A D D E N D U M

Project No.: 2501101
Project: EACS Restroom Renovations

Addendum No: 02
Date: 04/02/2025

ADDENDUM NO. 02, to Drawings and Specifications dated 03/12/2025, for the EACS Restroom Renovations for the East Allen County Schools; as prepared by ELEVATUS Architecture, 111 E. Wayne Street, Suite 555, Fort Wayne, IN 46802

① First Floor Architectural Notation Plan - Base Bid 1/4" = 1'-0"

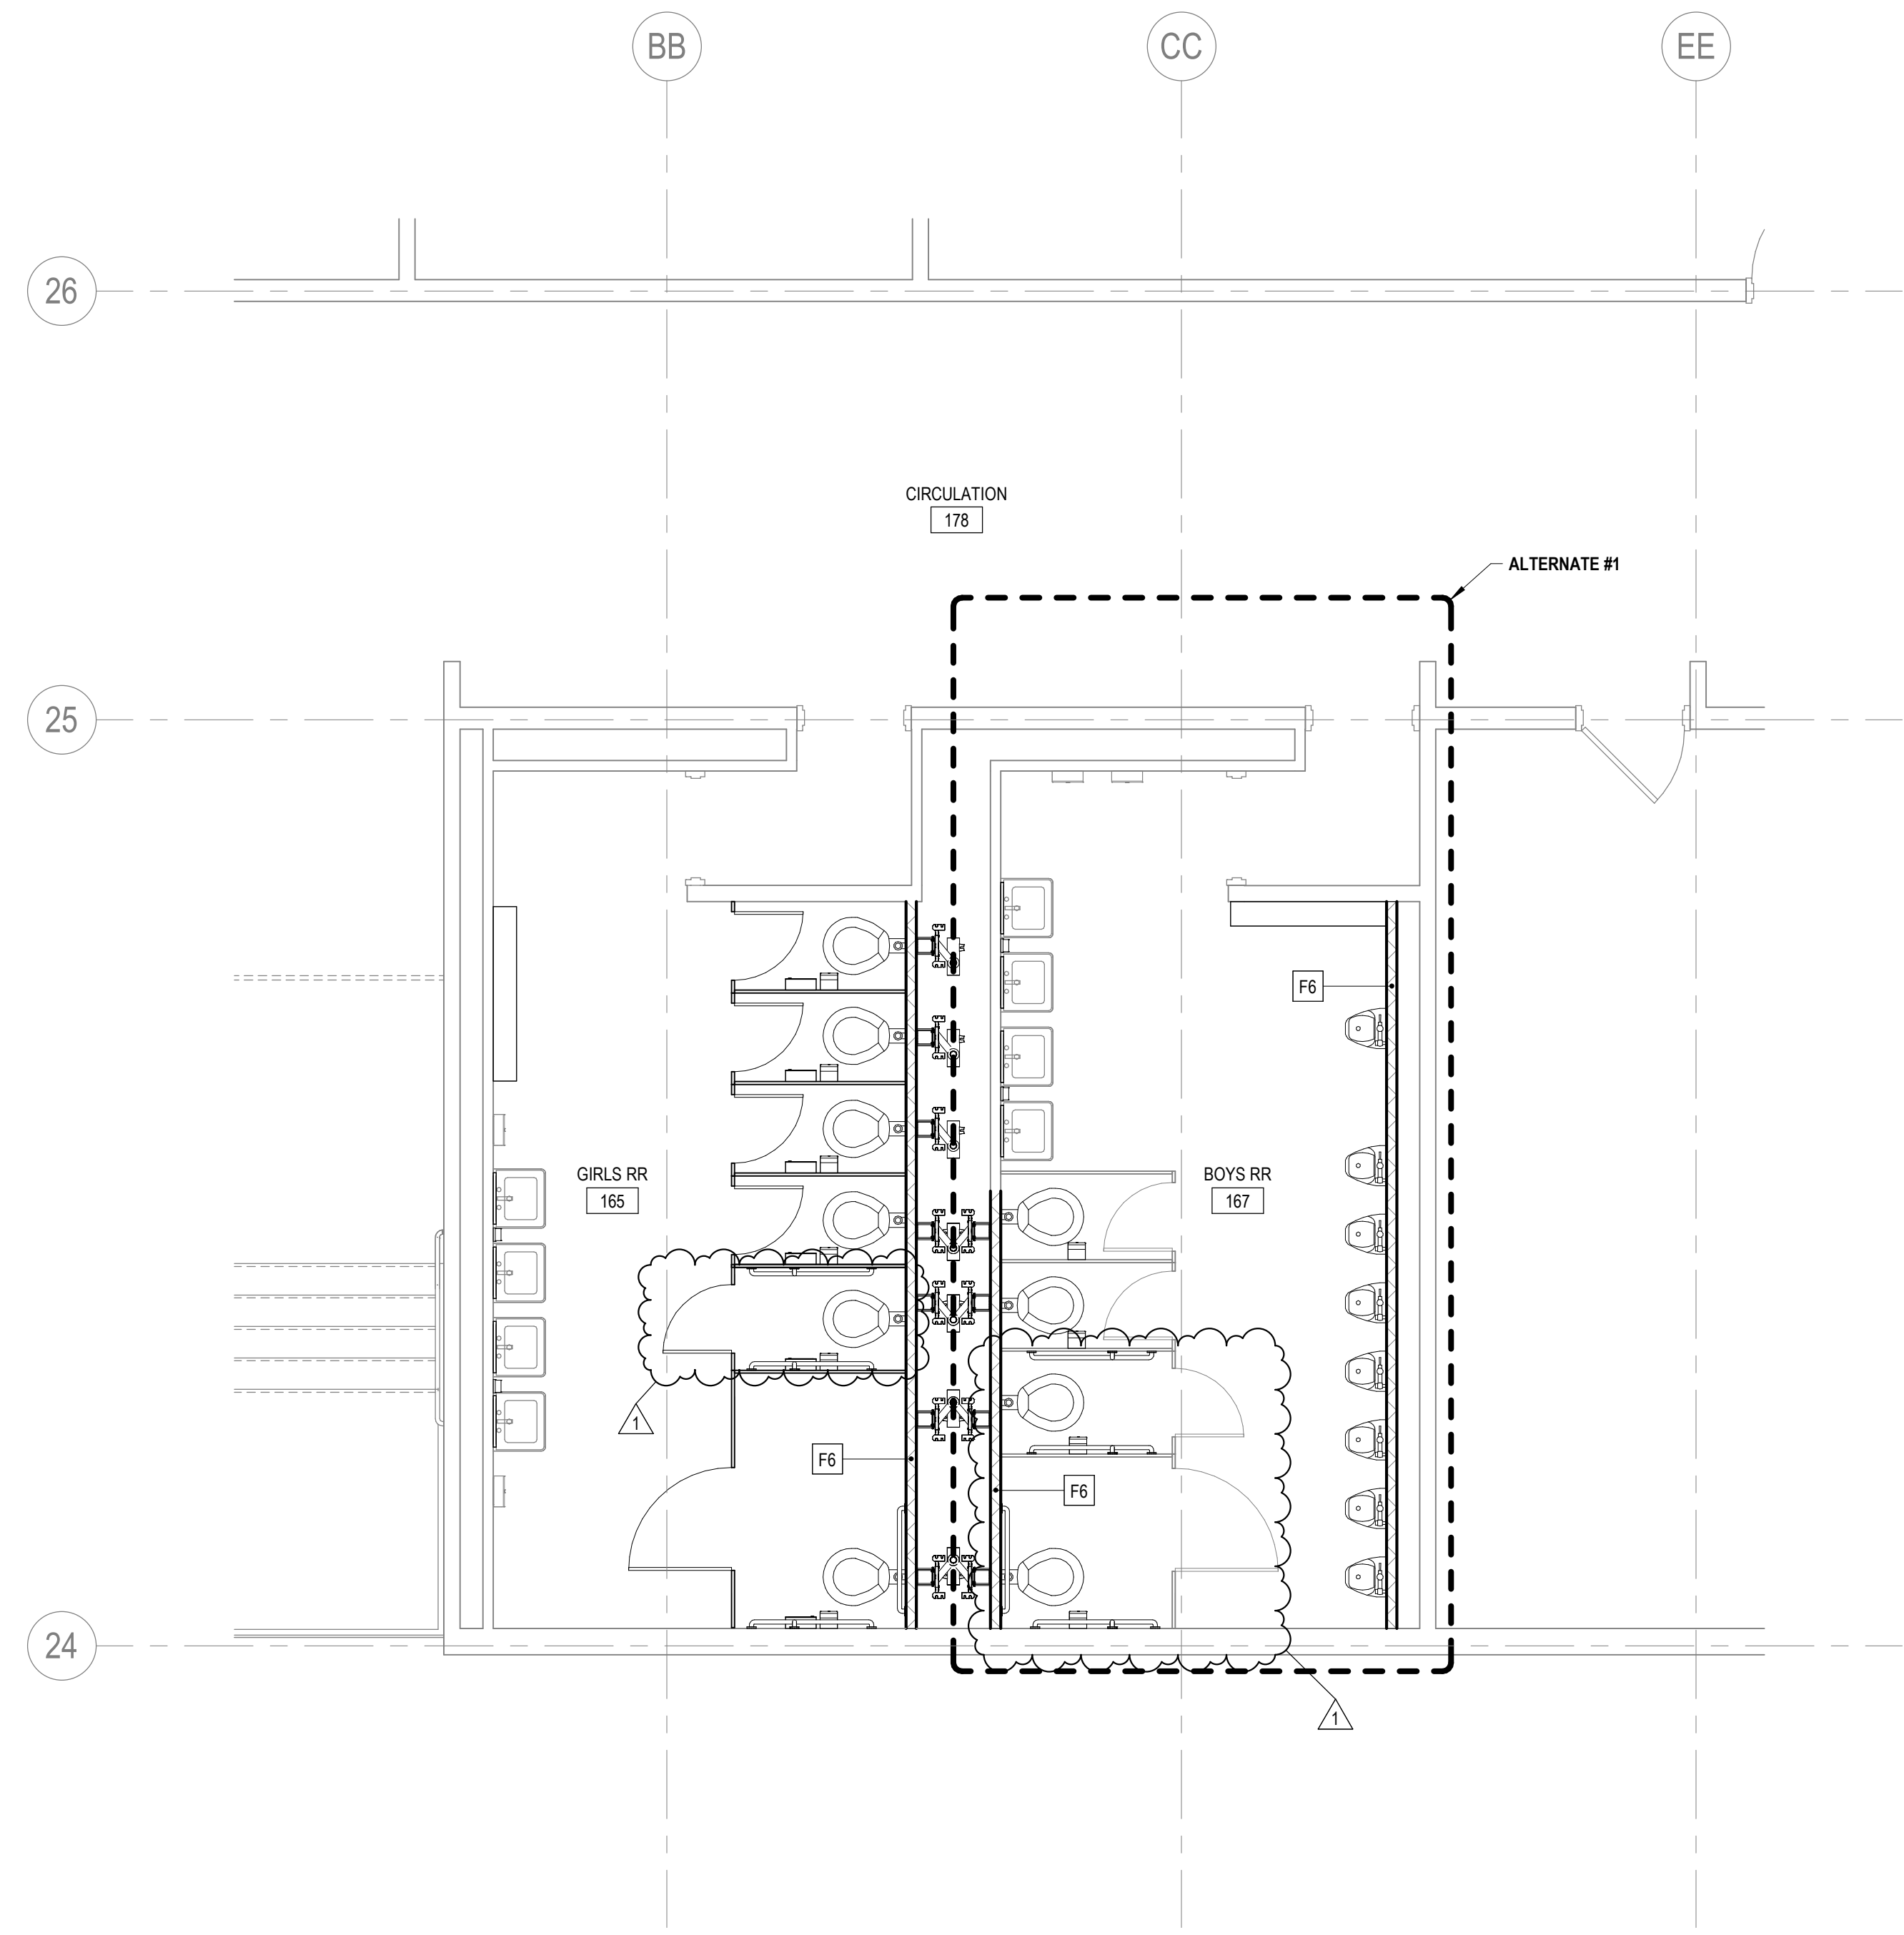
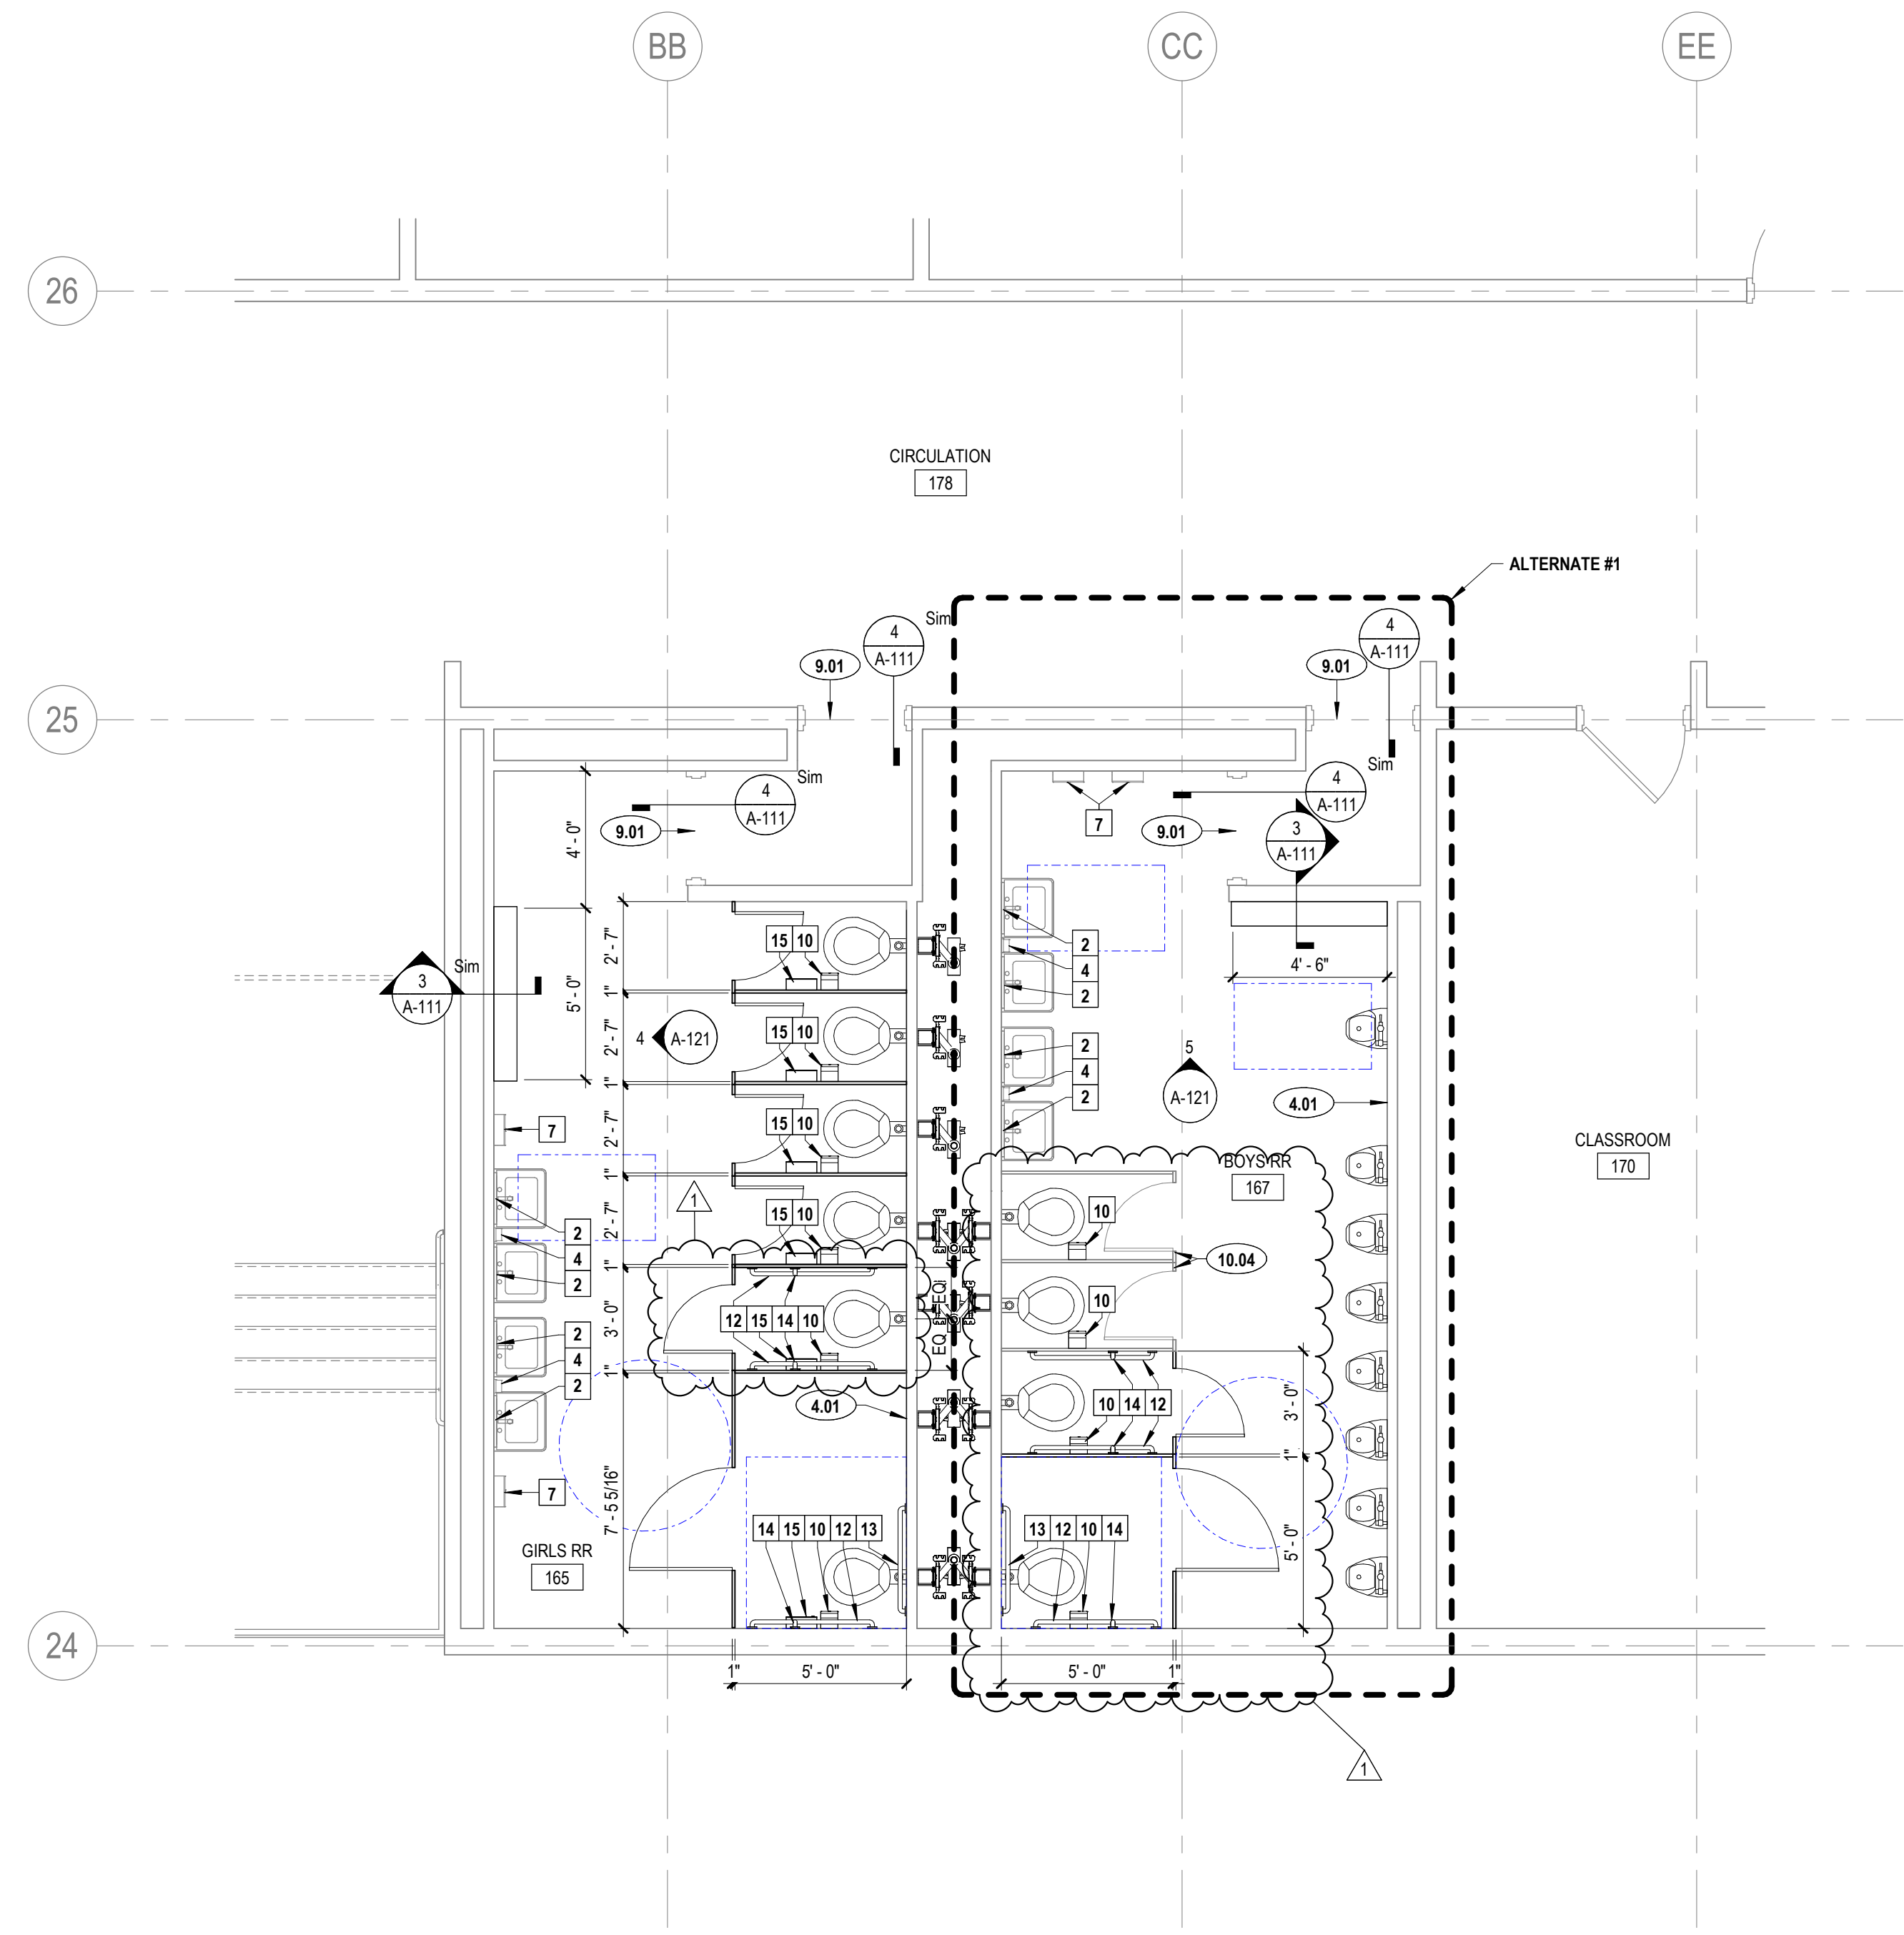
ITEM NO. 1.03 - DRAWING NO. A-111 Architectural Notation Plan – First Floor

- A. Addition of vertical grab bars in ambulatory stall in Girls RR.
- B. Revision of toilet partition door swing on ambulatory stall in Girls RR.
- C. Addition of ambulatory stall and associated grab bars in Boys RR.
- D. Revision of ADA toilet partition in Boys RR.
- E. Revision to location of Floor Plan Note 10.04 in Boys RR.
